BROWN ENGINEERING CO.	
ENGINEERING CONSULTANTS 1000 CENTRAL PARKWAY N. 8-235 SAN ANTONIO, TEXAS 78232 PHONE (512) 484-5511	NO. DATE
UNIT TA MP: MS2	REVISIONS
ORION PARTNERS, INC. VISTA DEL NORTE DOS	
POADO P	
SHEET NO. 1	
OF 1	
339

RE: Vista Del Norte Dos Subdivision POADP #339

The Development Review Committee has reviewed and accepted your Vista Del Norte Dos Subdivision Preliminary Overall Area Development Plan #339. A signed copy is enclosed for your files.

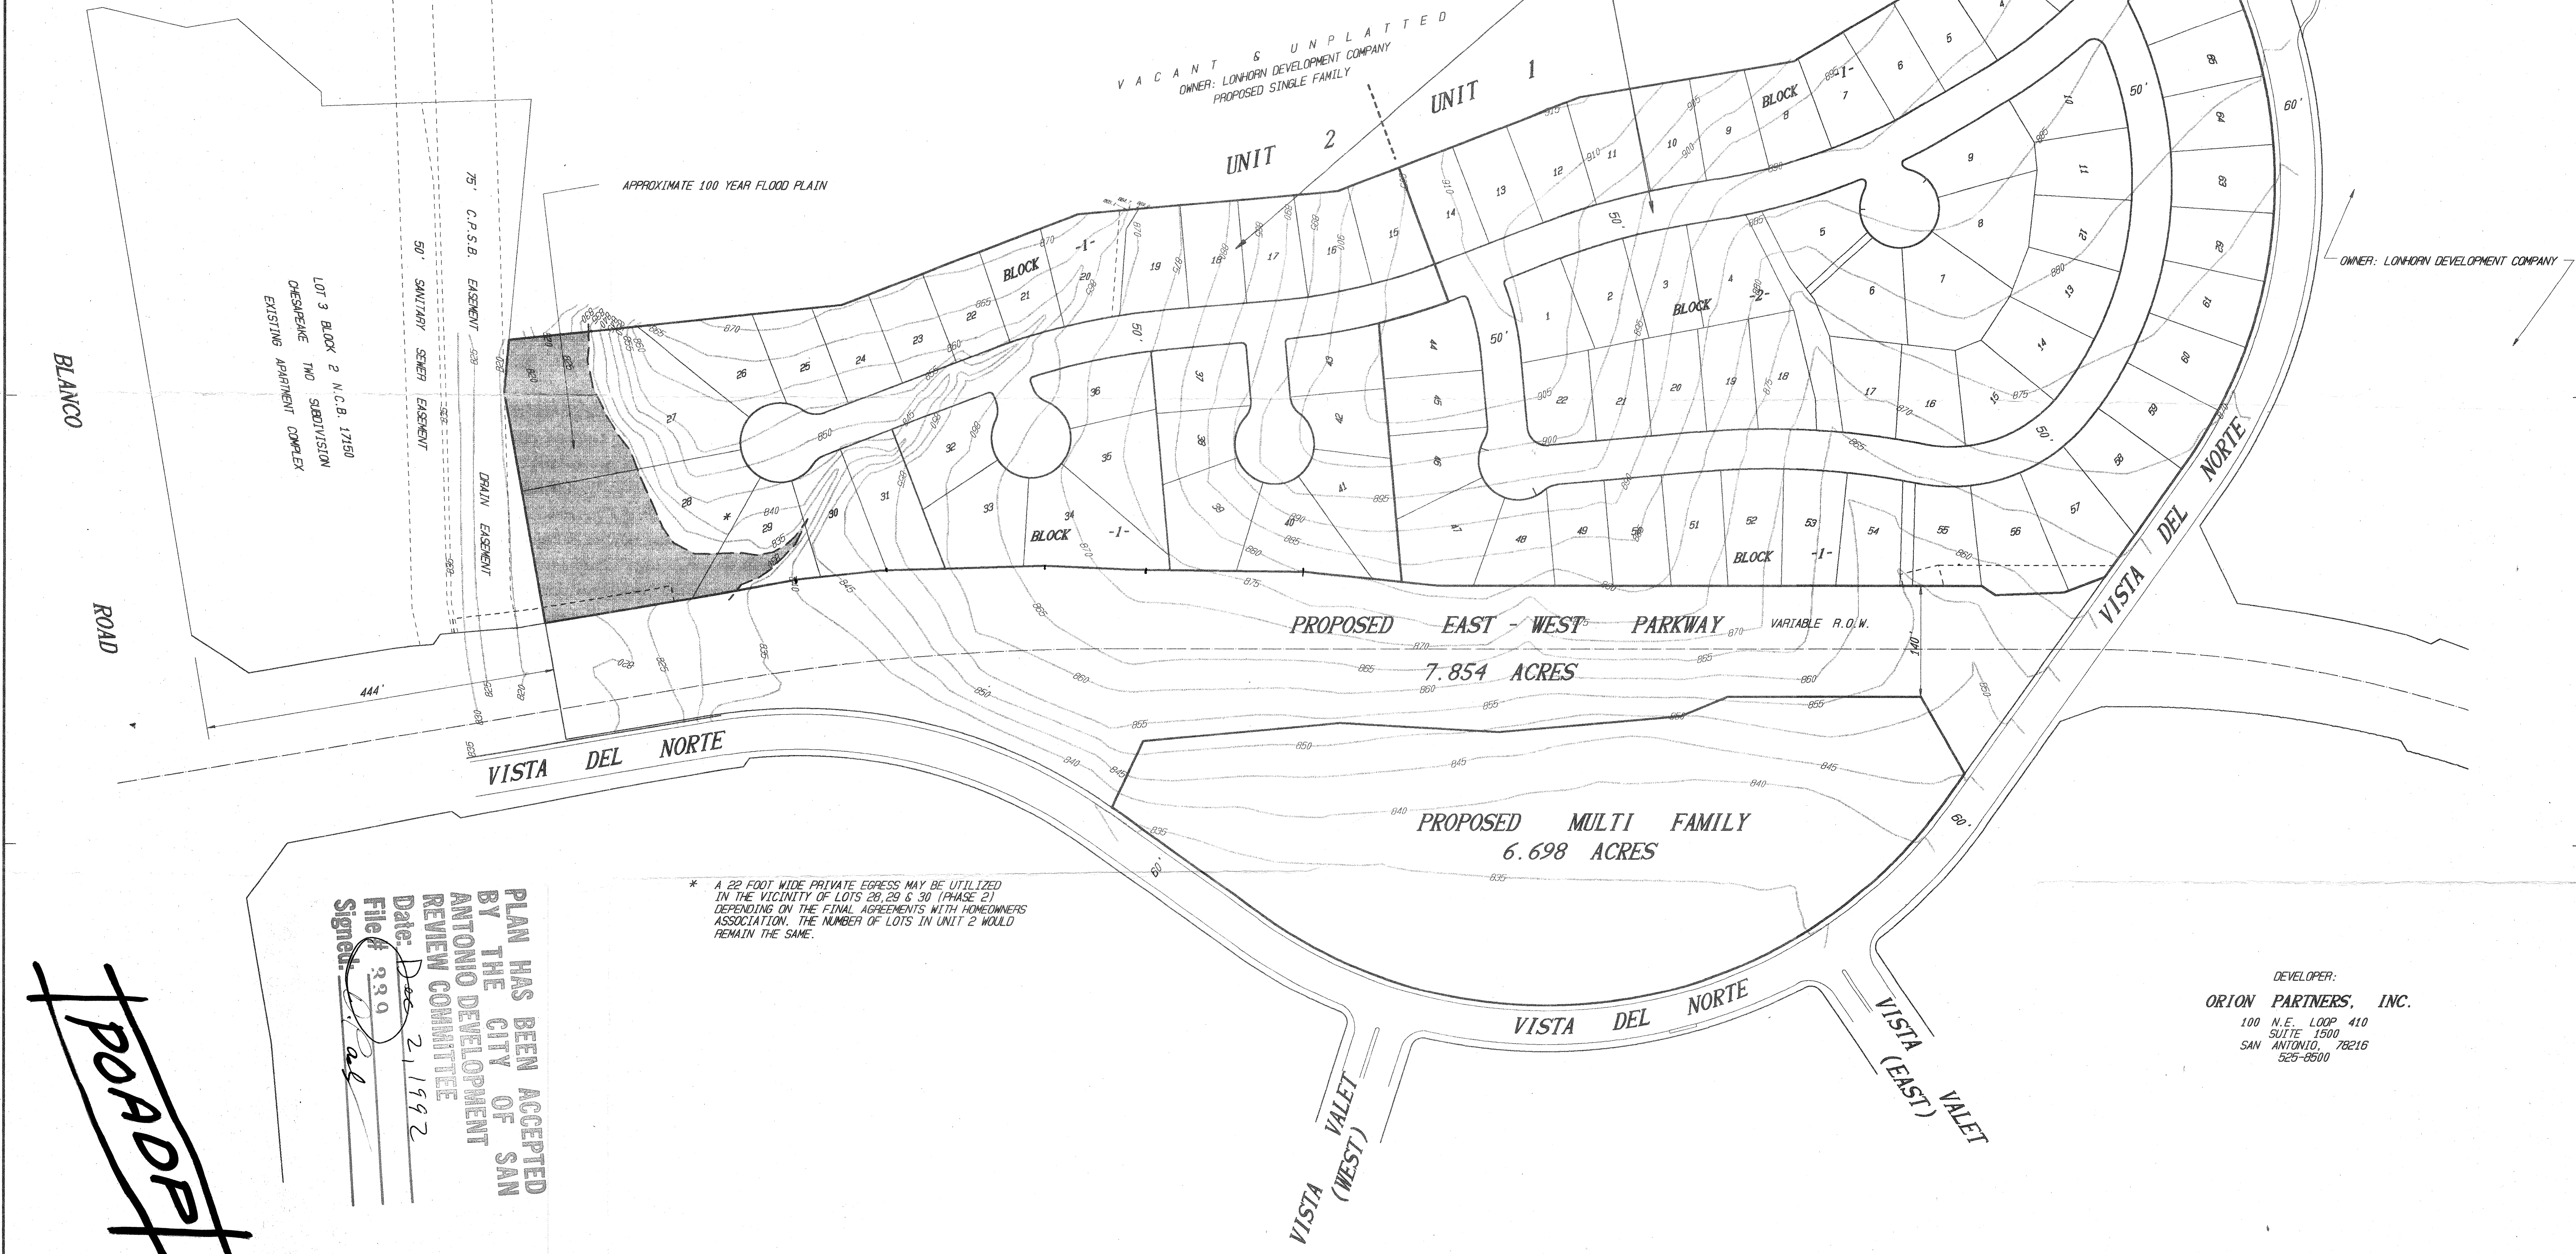
Although your plan is in general conformance with the Unified Development Code, the following will be required at the time of plat submittal:

1. In accordance with sections 35-4008 and 35-4113, street right-of-way dedication for the full width of the East-West Parkway will be required in conjunction with the platting of your property.
2. The Fire Department has indicated a need for two standard streets to access the proposed development. Although they require a standard street section, Planning staff will support a safety lane subject to approval by the Director of Public Works.
3. In accordance with section 35-4108, it is deemed necessary that a vehicular non-access easement be required on all lots abutting the proposed "East-West Parkway".

4. In accordance with section 35-4107, in general, cul-de-sacs may not exceed 500 feet in length. At the time of plat submittal, you will be required to submit justification for the excessive length along the east-west cul-de-sac shown on your plan.

In the interest of providing emergency services to the future residents of the proposed development, the San Antonio Fire Department requires two (2) remote access roads to Orion's Vista Del Norte Dos.
